PERMIT

SEWAGE DISPOSAL SYSTEM

A REPAIR

SUBDIVISION _____ LOT _____ ROAD 7036 Mink Hollow Road

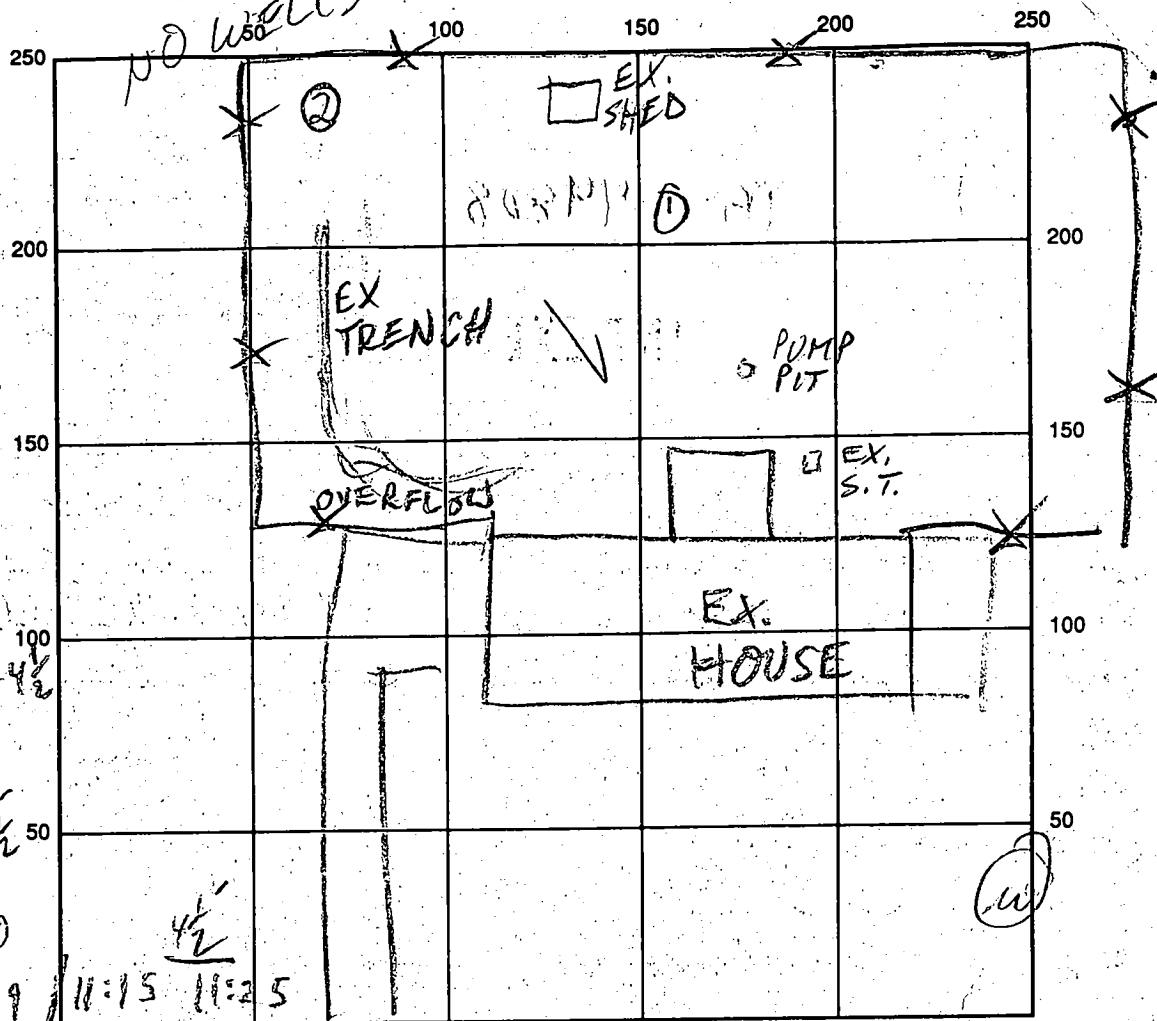
orange	2
cl	
brn lm	4 1/2
H ₂ O seeping	5
H ₂ O	6

orange	
si cl lm	4 - 4 1/2
brn	
gray si	7 - 7 1/2
lm	
H ₂ O seeping	10

no walls

11:02 11:09 11:15 11:25
 VERY SLOW 11:25 11:40

REMARKS: 1/13/97 SHALLOW H₂O TABLE; ONLY POSS. LOCATION -
 OK TO START MR 2/3/97 NEW CONTRACTOR; T/C W/OWNER:
 ADVISED HER SYSTEM IS "EXPERIMENTAL" & ADVISED HER TO
 LIMIT H₂O USAGE MR

LEACHING BED 20' X 25' INLET 3 1/2' BOT 5 1/2'

GRAVEL 4 BED BOTTOM LEVEL

IN LEFT REAR COR OR PROP AS HIGH AS POSS.
